SERVICE BULLETIN N° 13

Equipment concerned : Air intake, below carburetor

Aircraft concerned : All C.E.A. aircraft equipped with an air intake.

AVION DA ²⁵³ (cas n° 1)

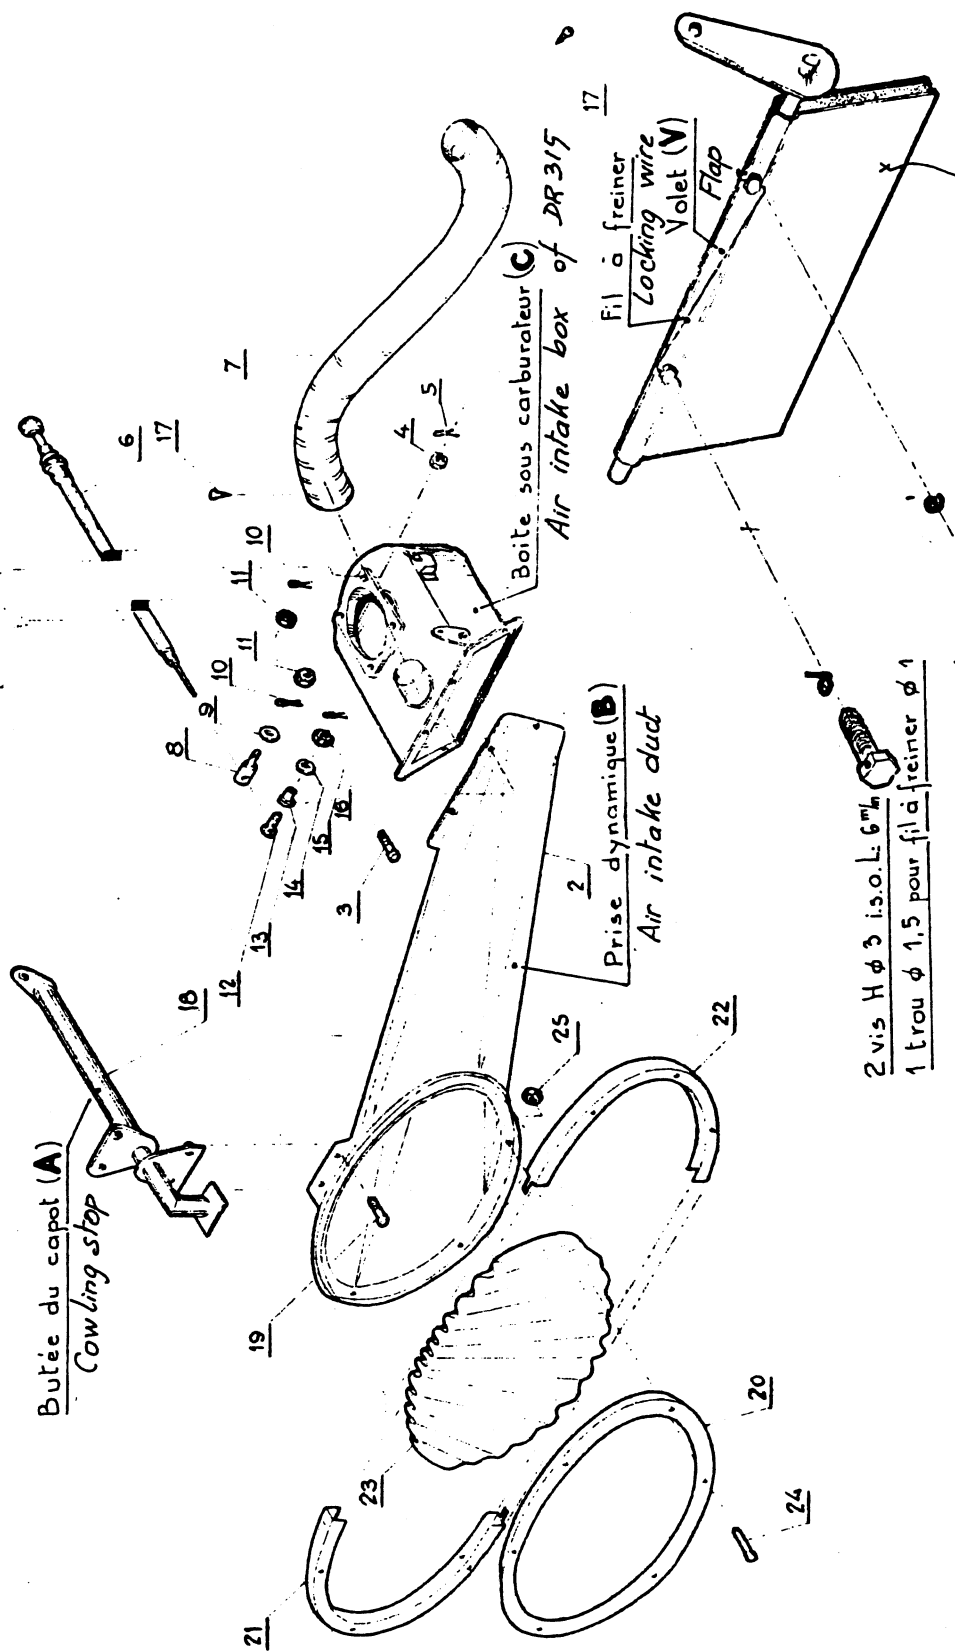
The flap is secured to the shaft by means of round head screws which, in spite of the lock washers, may sometimes become loose.

To eliminate such risks, replace the round head screws by cheese head screws drilled to accommodate a locking wire. Lock the screws together with locking wire (see attached diagram, Case n°1).

2 vis H ϕ 3 is.o. L. 6^m
 1 trou ϕ 1,5 pour fil à freiner ϕ 4

2 iso H screws 3mm dia.
 x 6 mm
 1,5 mm hole for 1mm dia. lock. wire

- 1 - Remove top and bottom engine cowlings
- 2 - Remove the 2 bolts securing the air intake duct (B) to the lower cowling stop (A).
- 3 - Remove the 4 bolts securing the air intake duct (B) to the air intake box (C) (carb. heater).
- 4 - Remove the 2 screws (d and e) from the flap (V), as well as the lock washers.
Fit, instead, the 2 cheese head screws and washers. Lock both screws together with locking wire.
- 5 - Re-assemble the other components.

cas n°2

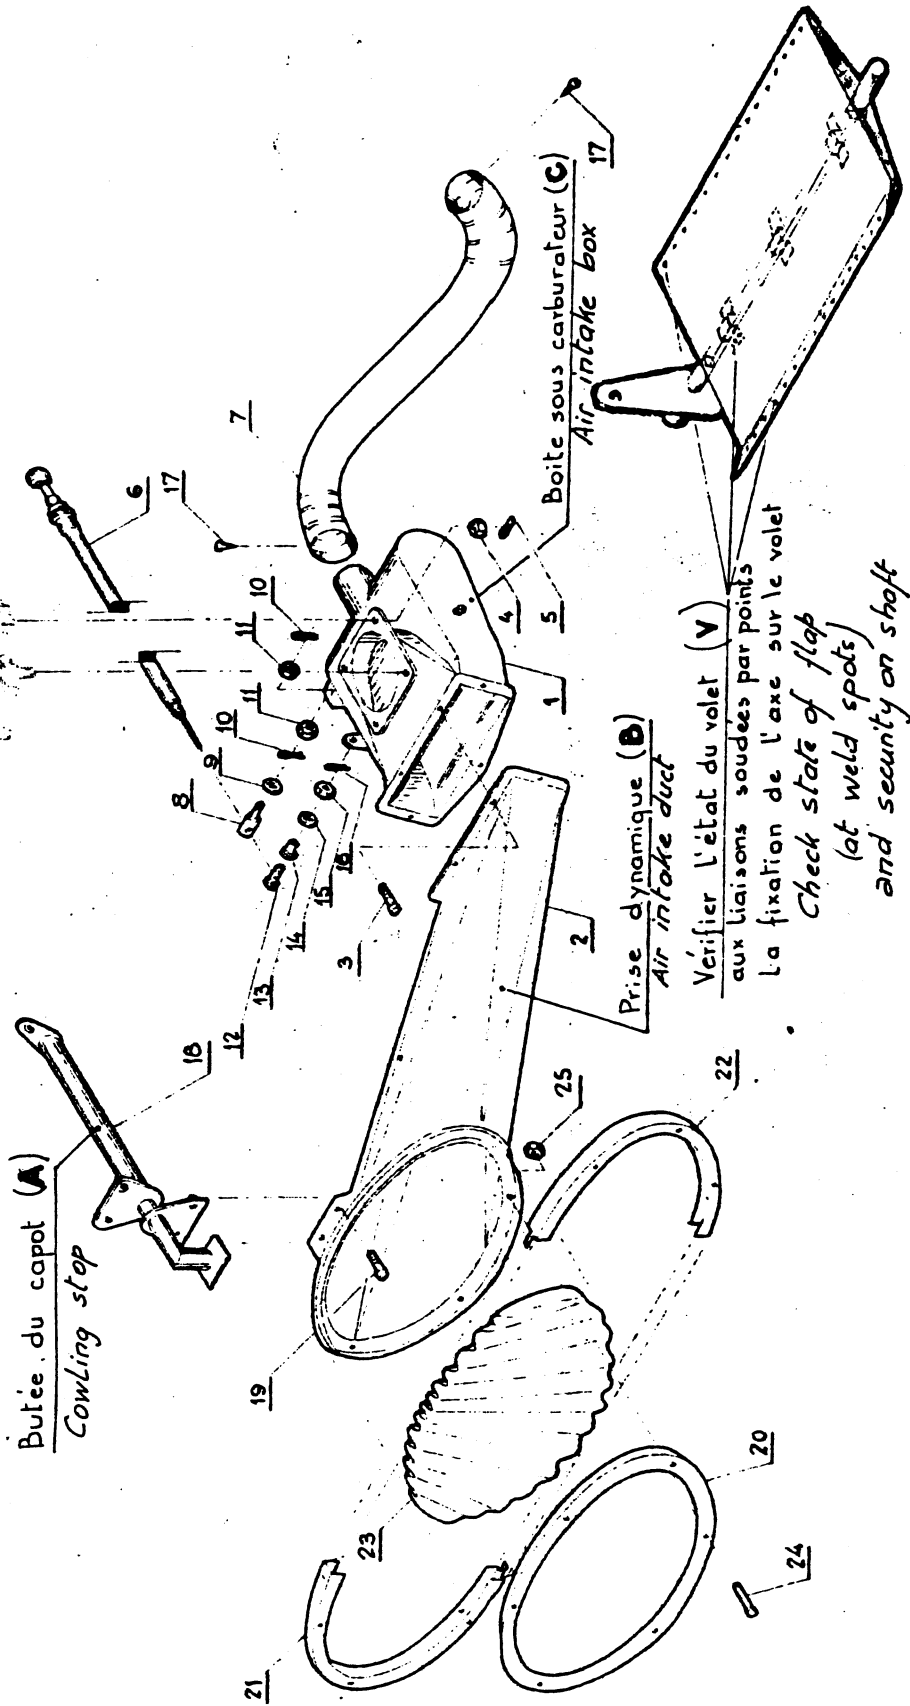
Vibrations may lead to the cracking, or even the parting, of the weld spots securing the top flap surface to the bottom surface (see attached disassembly procedure, Case n°2 and some examples of critical cases which necessitate the replacement of the air intake box).

- 1 - Remove control cables and conduits :
 - a) - carburetor butterfly control.
 - b) - carburetor heater control.
- 2 - Remove the Parker screw securing the flexible heater duct to the air intake box (C).
- 3 - Cut the 1 mm dia. locking wire securing the 2 1/4" dia. screws inside the air intake box (C).
- 4 - Remove the 2 1/4" internal screws.
2 external nuts
- 5 - Remove the assembly, taking care not to damage the gasket.

CAS CRITIQUES (Critical Cases)
 (Case 7-2)
CAS n°2

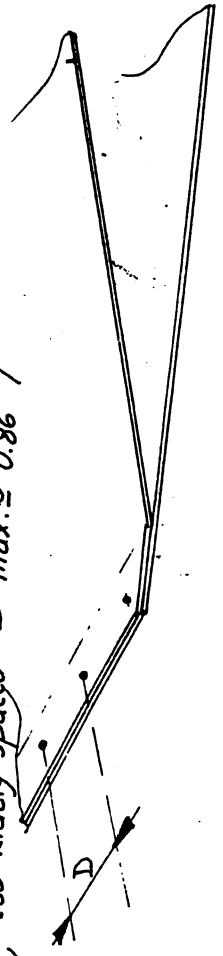
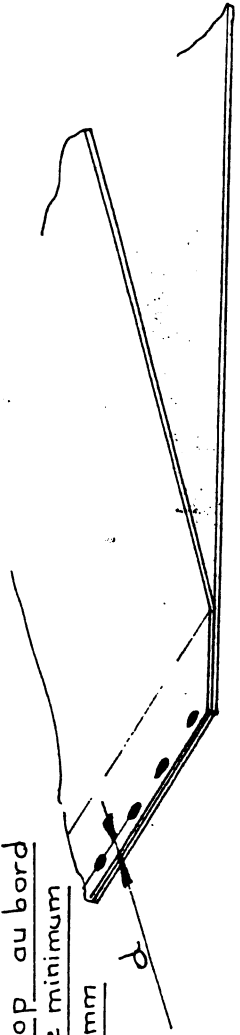
Point trop faible et trop écarté

Distance D maximum ≈ 23 mm

(Weak spot, too widely spaced "D" max. ≈ 0.86 ")

Point trop au bord

d = distance minimum

= 2 mm

(Spot too near the edge d. mini : 0.078")

Point à cheval sur le volet inférieur

(Spot on edge of lower flap surface)

Crises autour des points

(Cracks)
